CONSTRUCTION DOCUMENTS

FALCON MARKETPLACE

ISSUE	DATE
90% SUBMITTAL	5-6-19
REVISED	7-19-19
DESIGNED BY:	TDM
DRAWN BY:	KGV
CHECKED BY:	TDM
FILE NAME:	20988-CD-CVR

COVER SHEET

**MERIDIAN ROAD
STRIPING
PLAN**

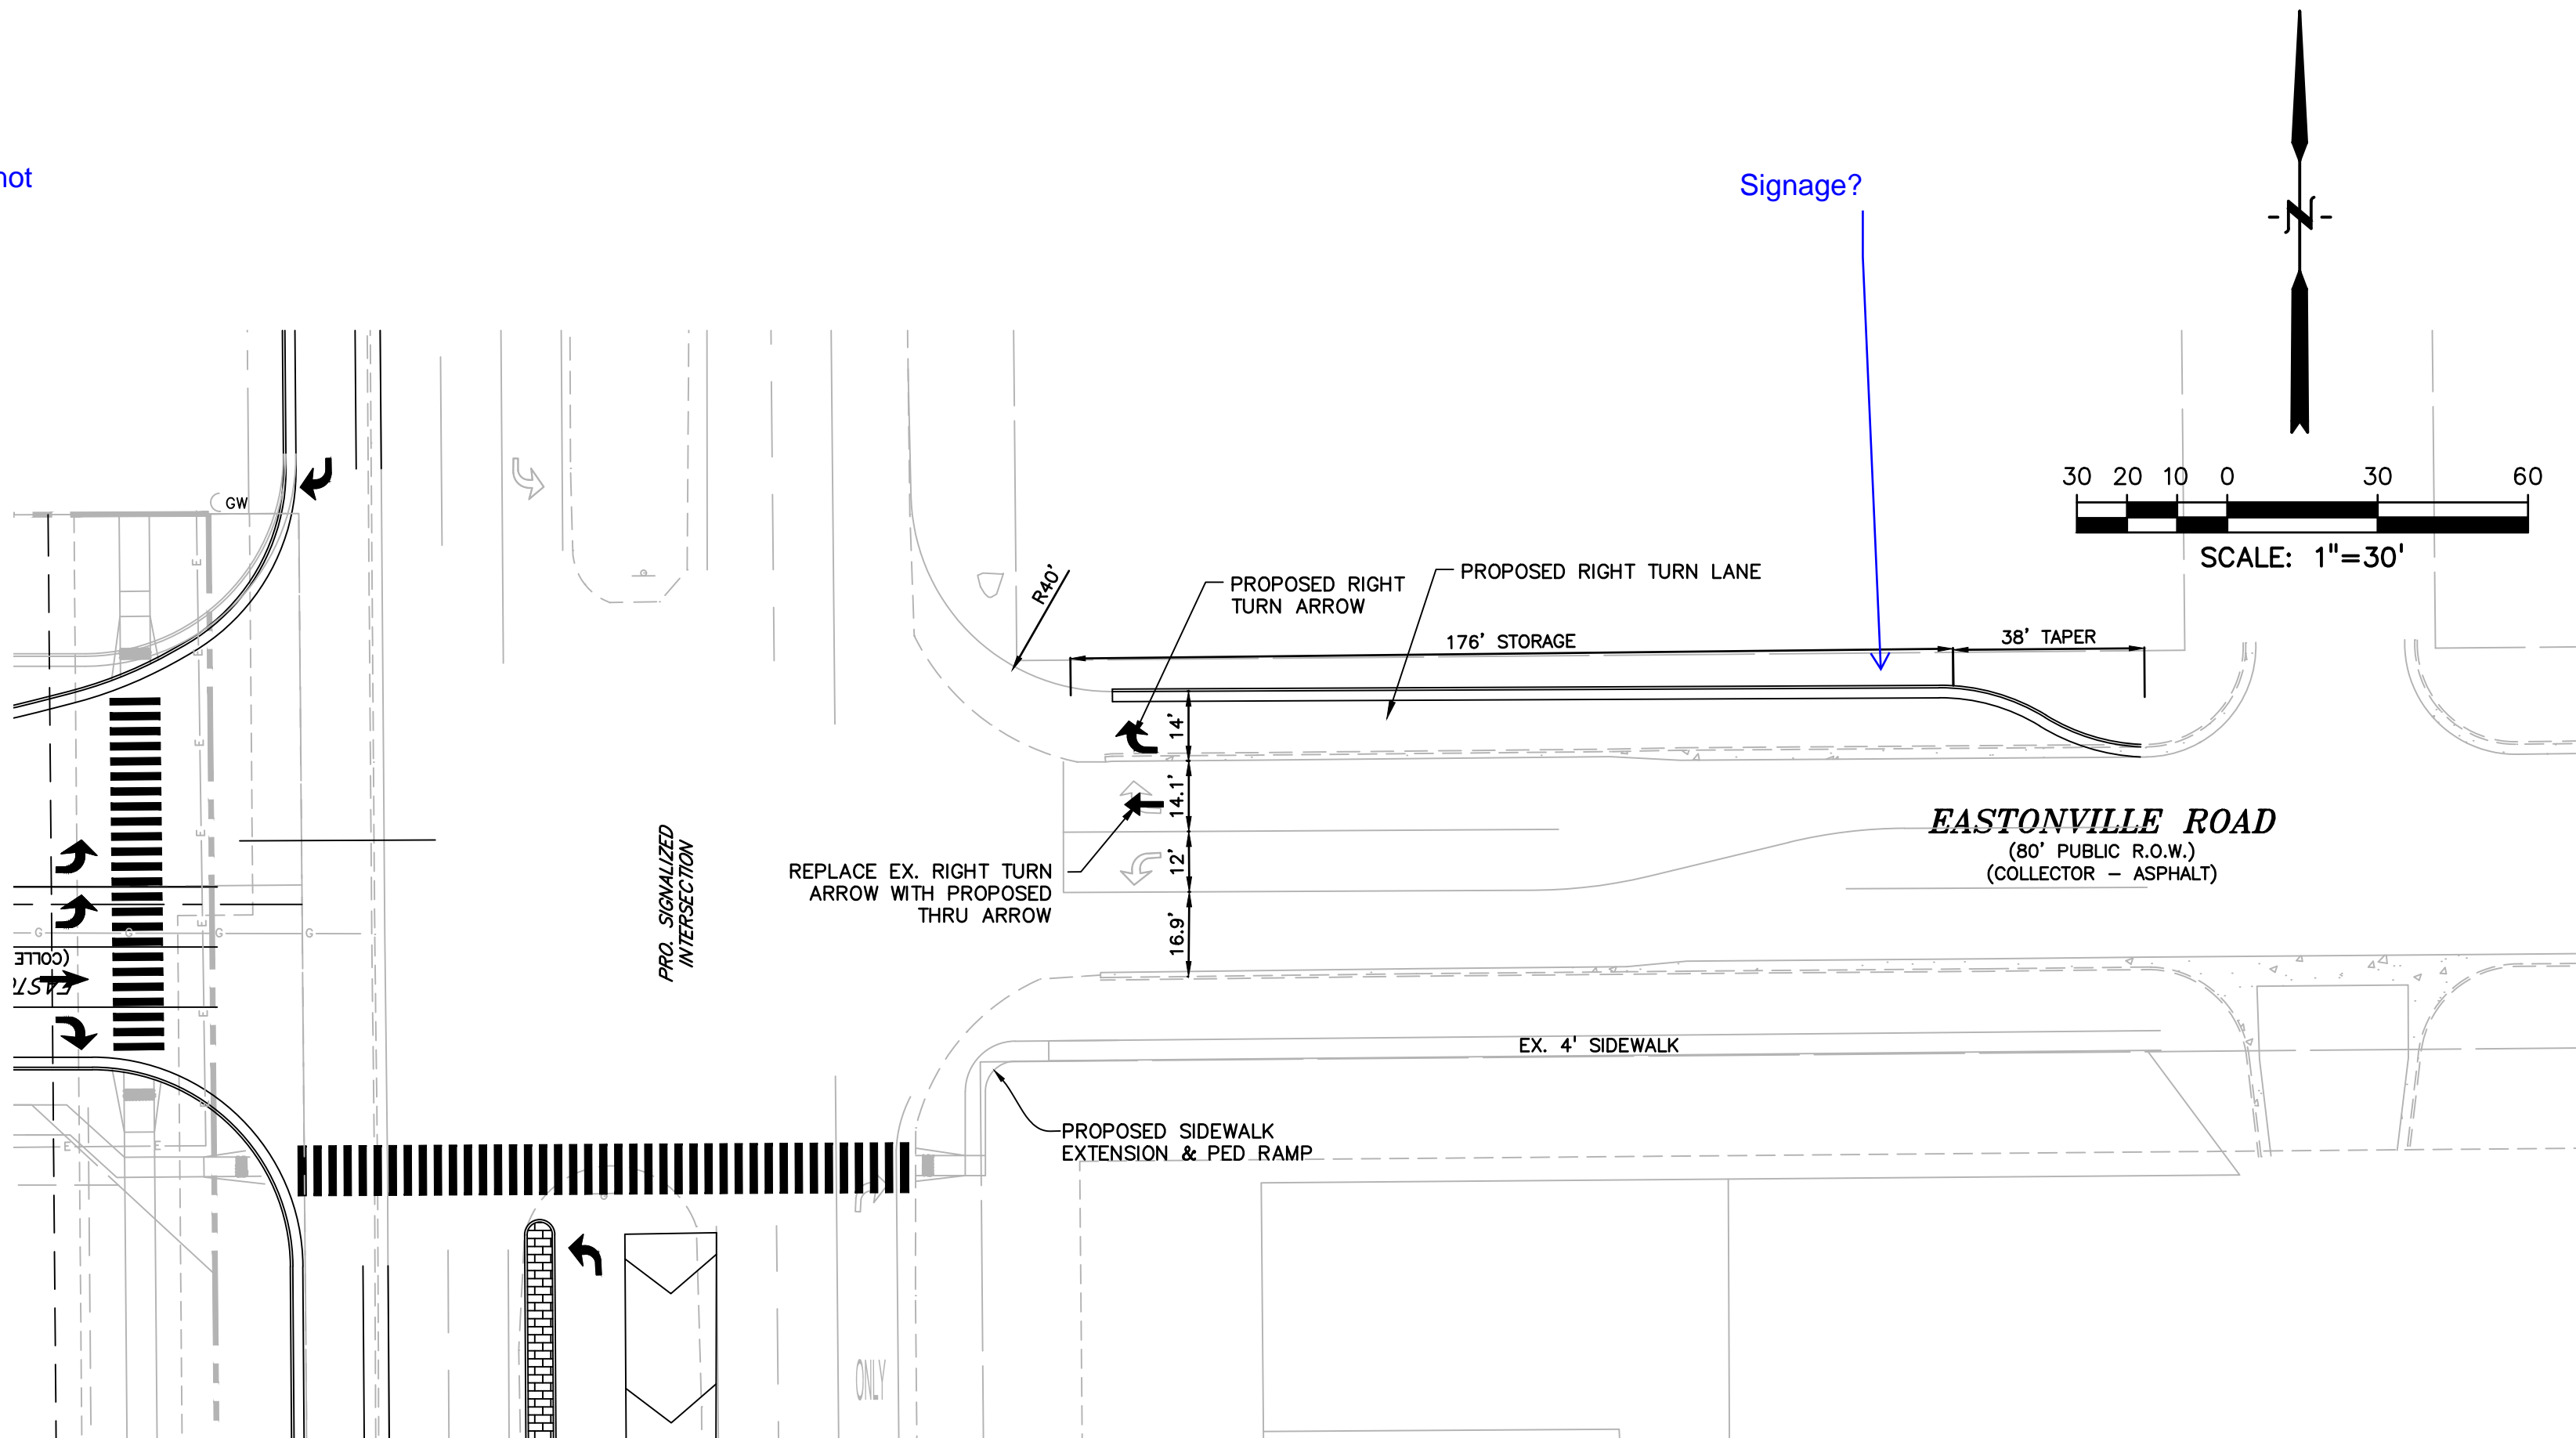
Reference MUTCD 3B.08 regarding dotted lane extensions for offset lanes and turn lanes.

Not found/not complete

STORM SEWER PLAN & PROFILE

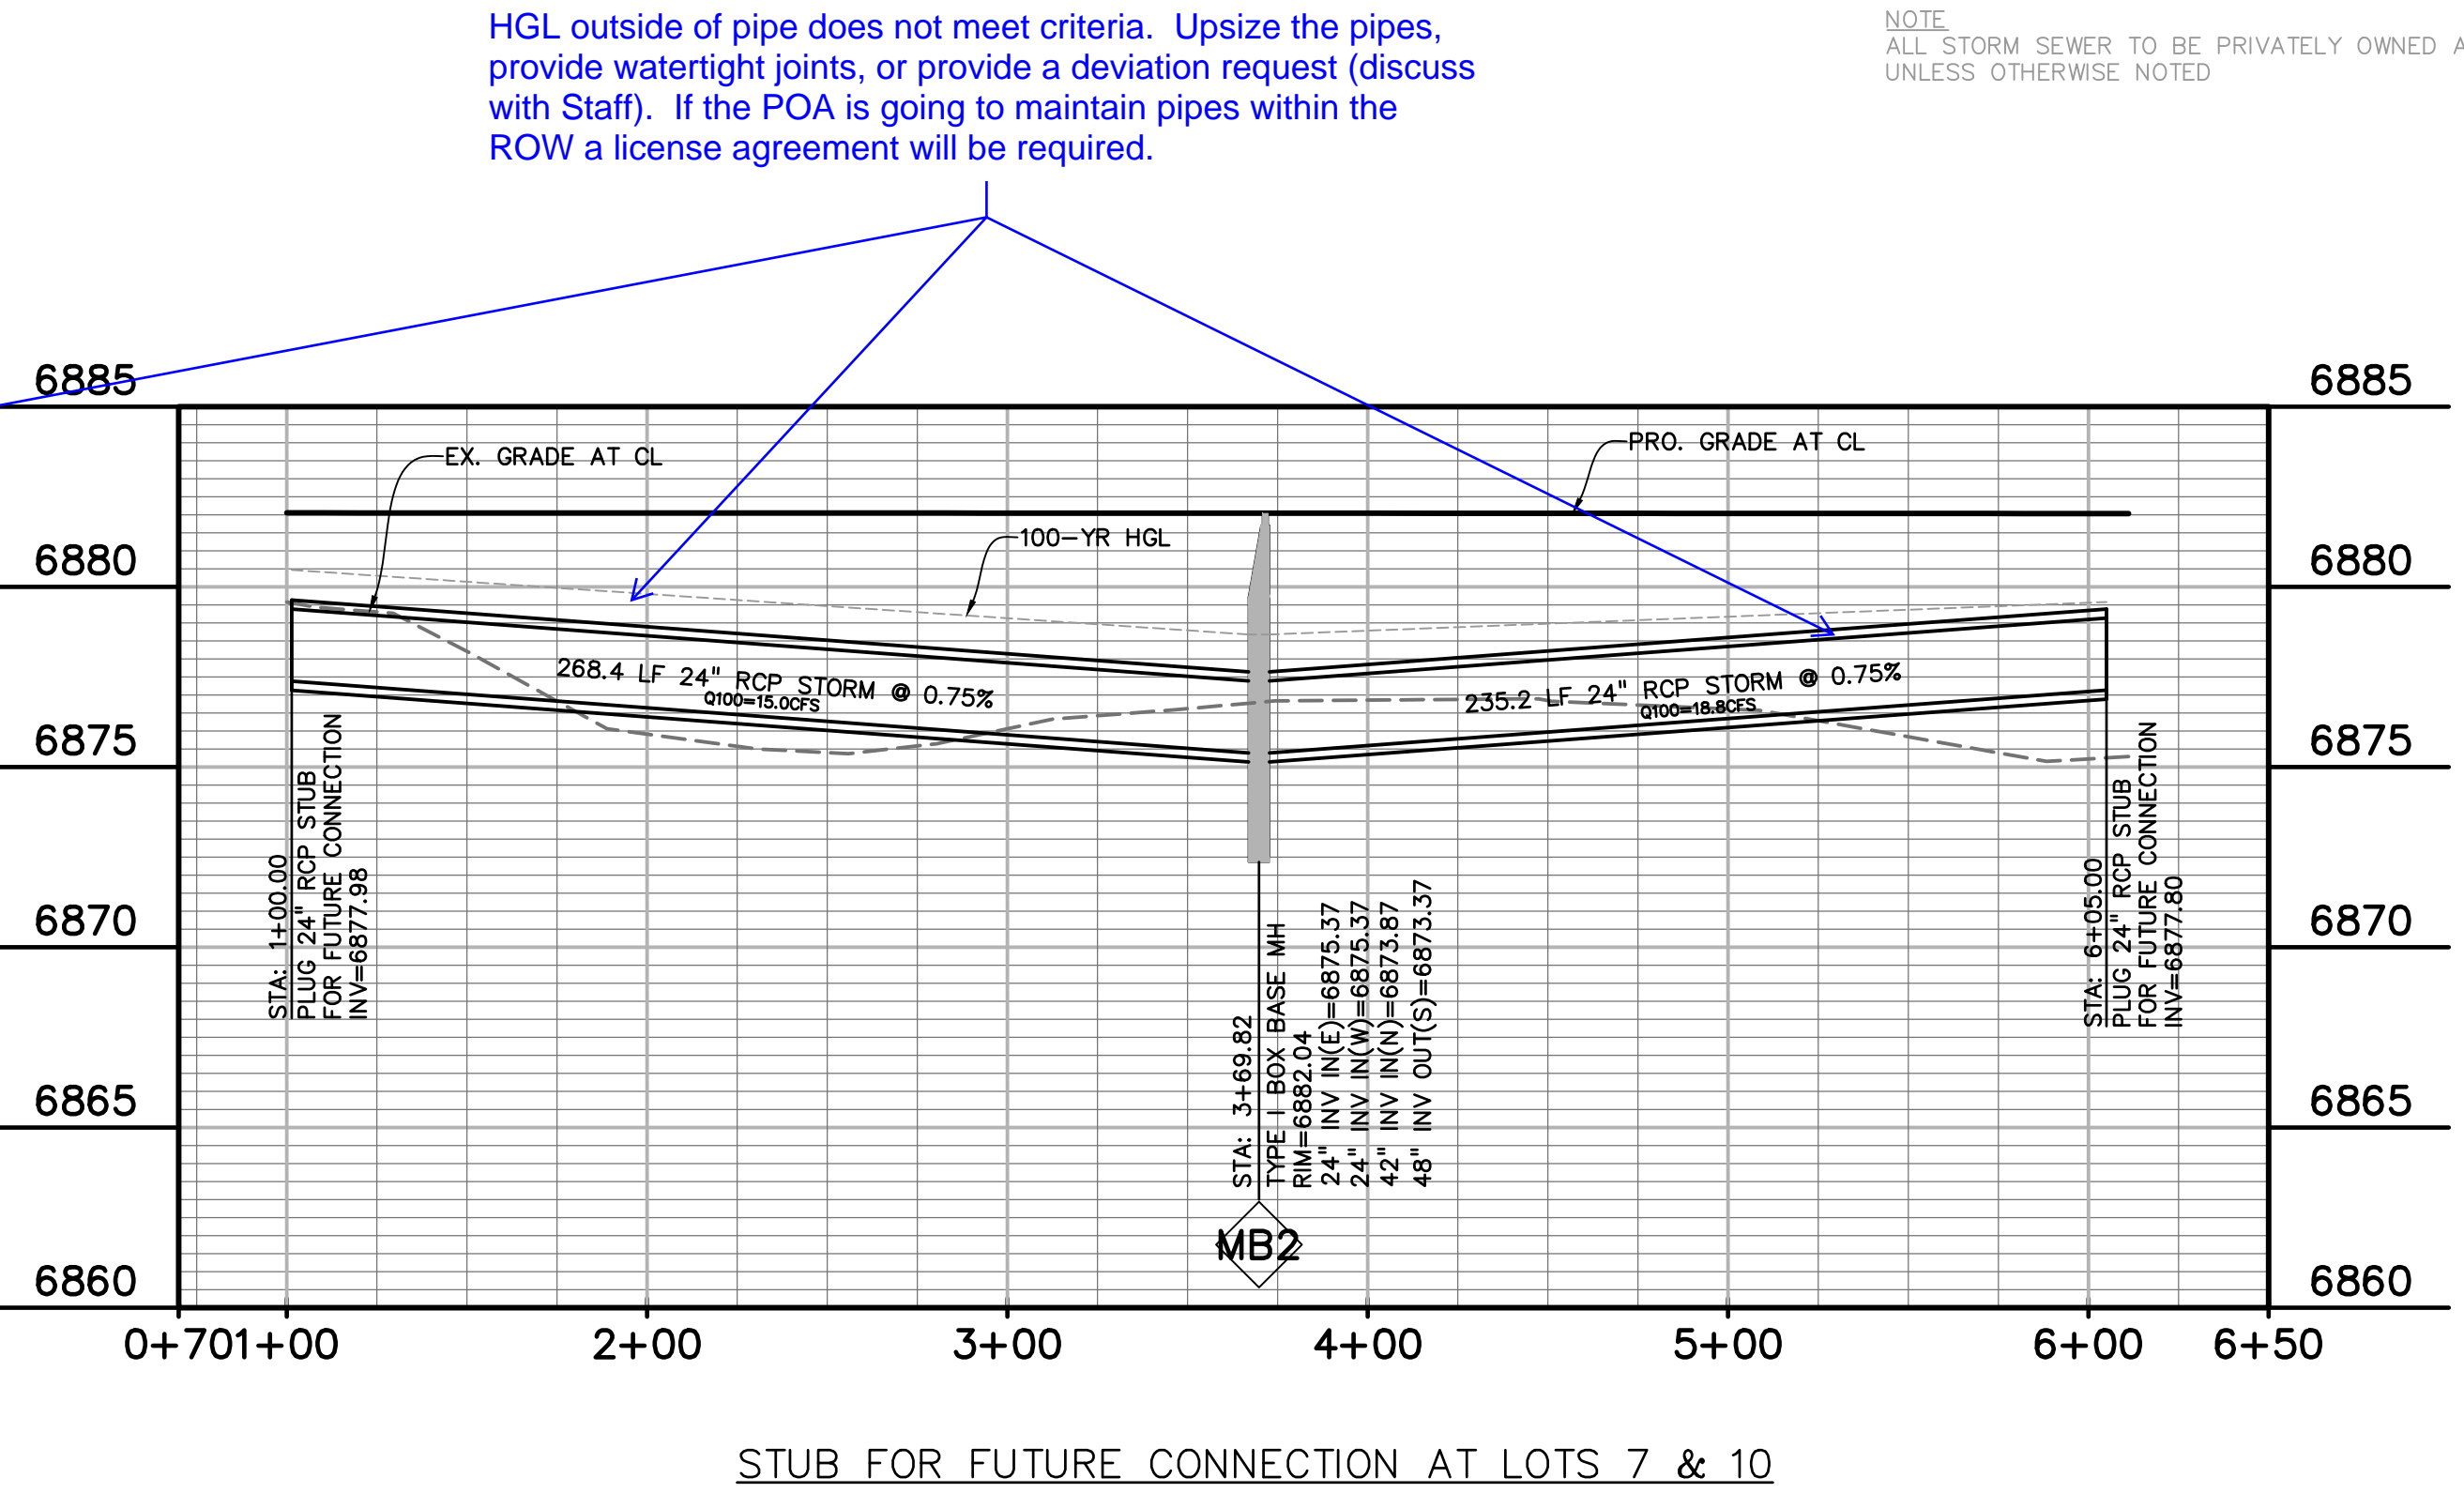
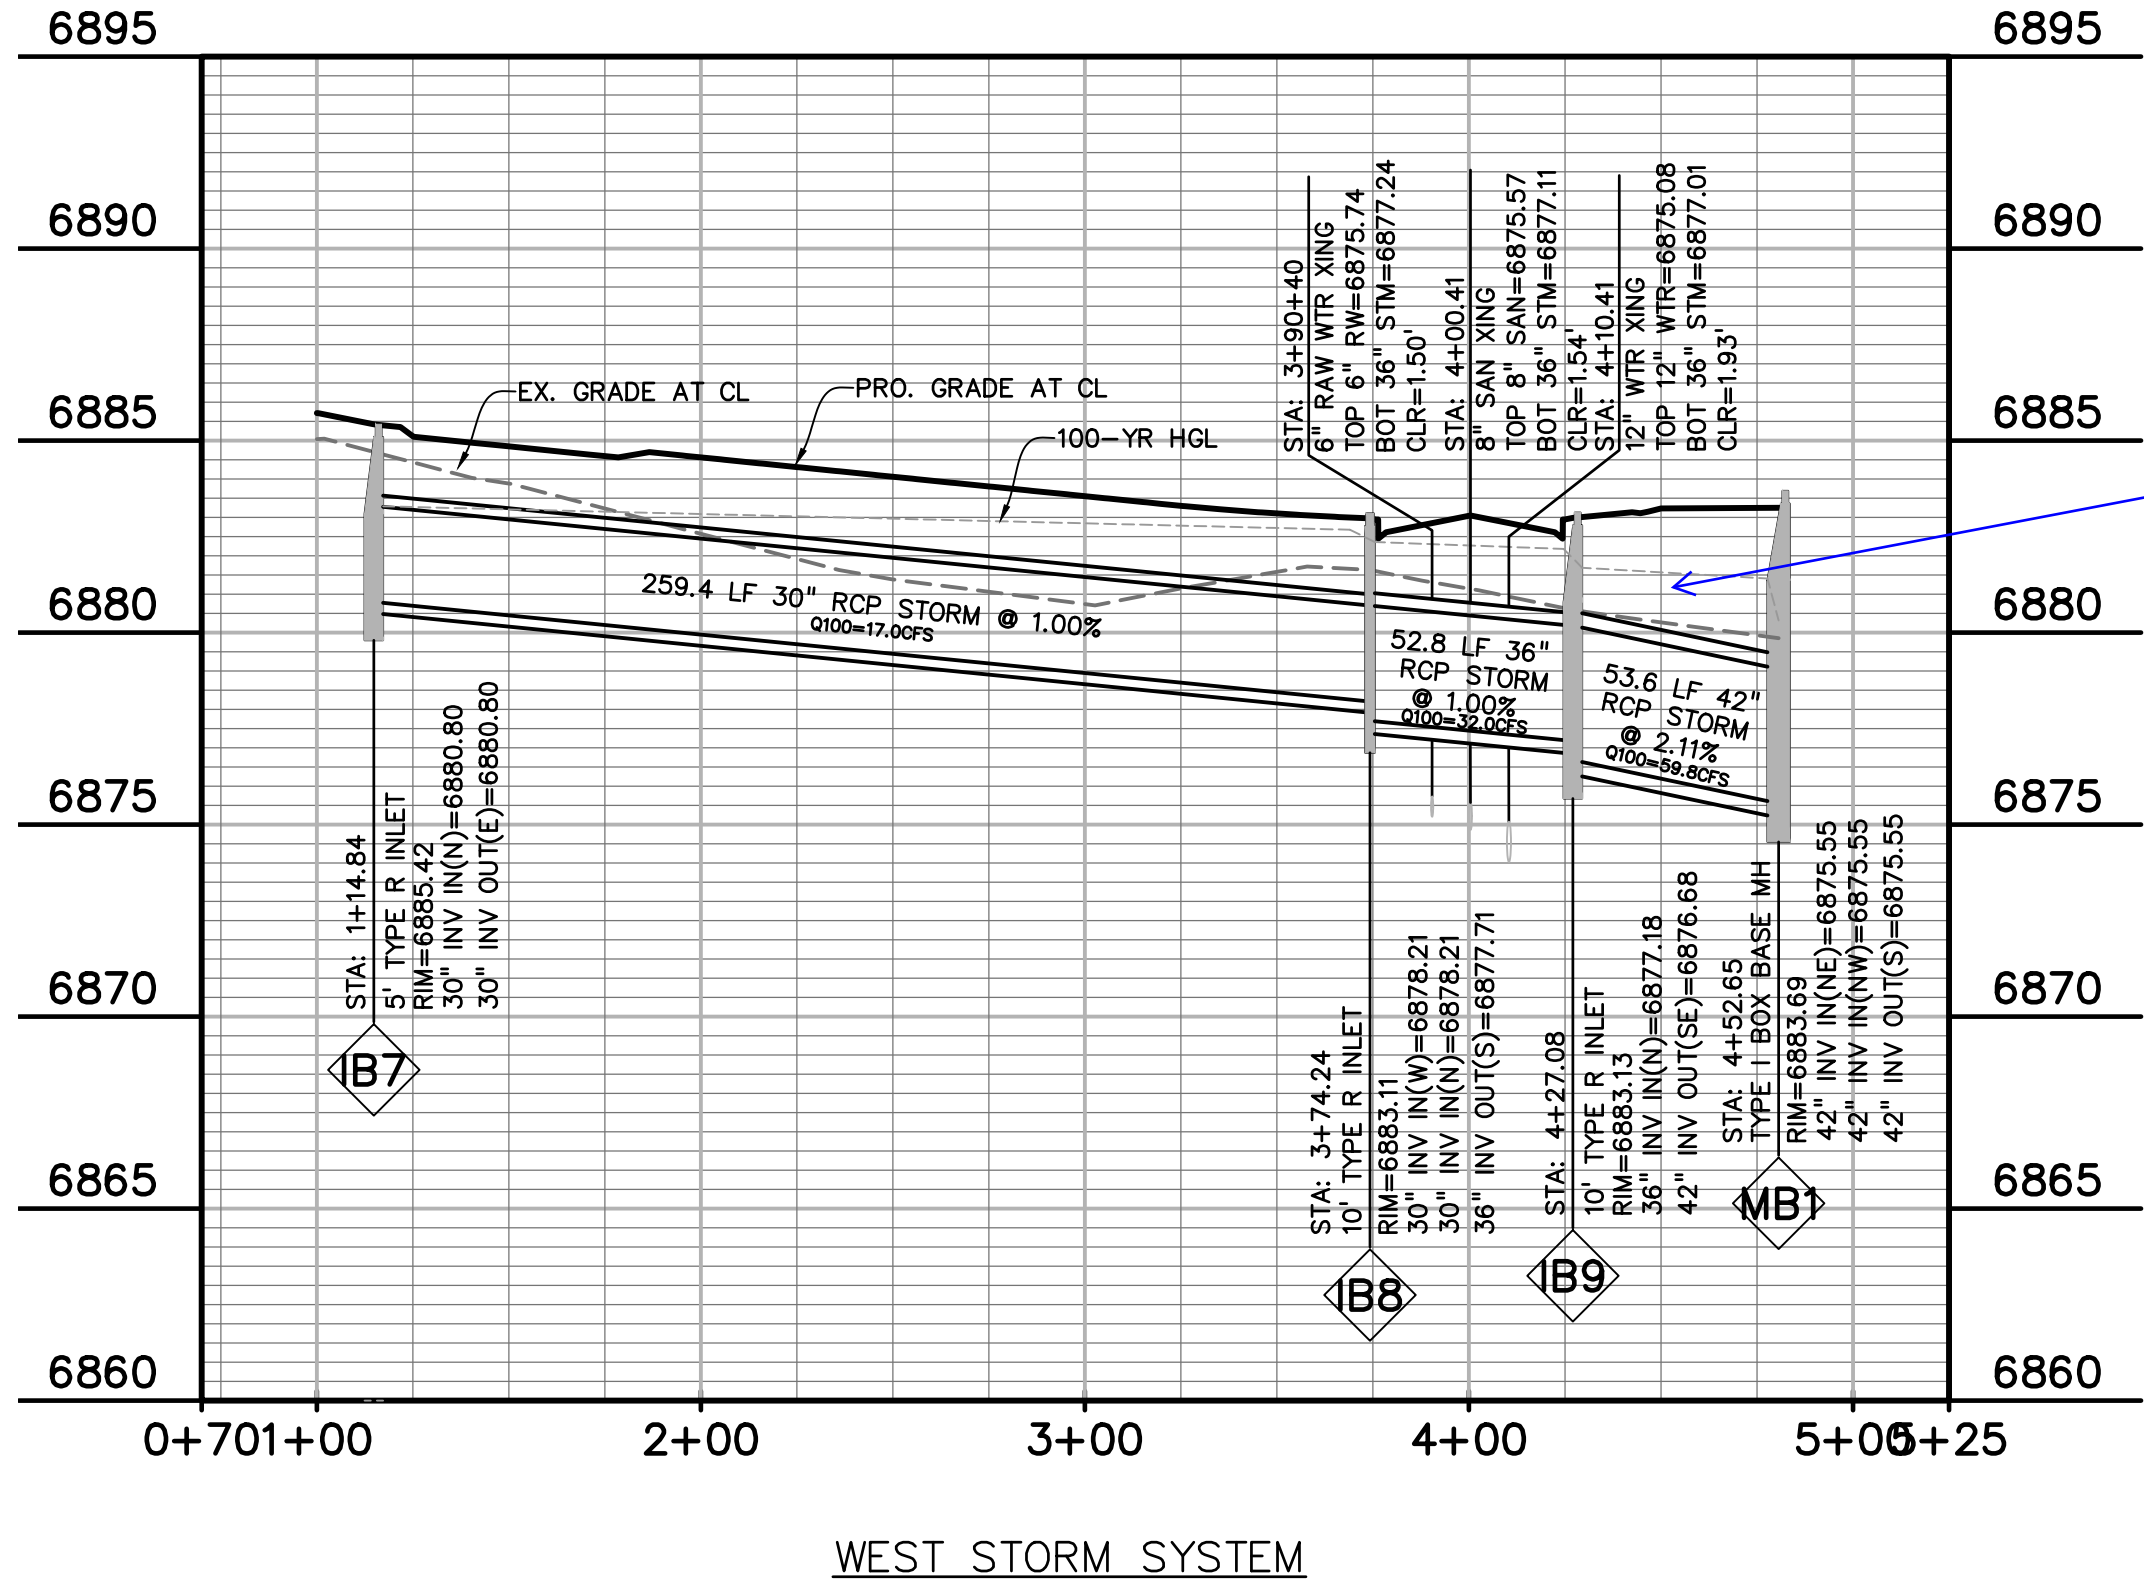
HGL outside of pipe does not meet criteria. Upsize the pipes, provide watertight joints, or provide a deviation request (discuss with Staff). If the POA is going to maintain pipes within the ROW a license agreement will be required.
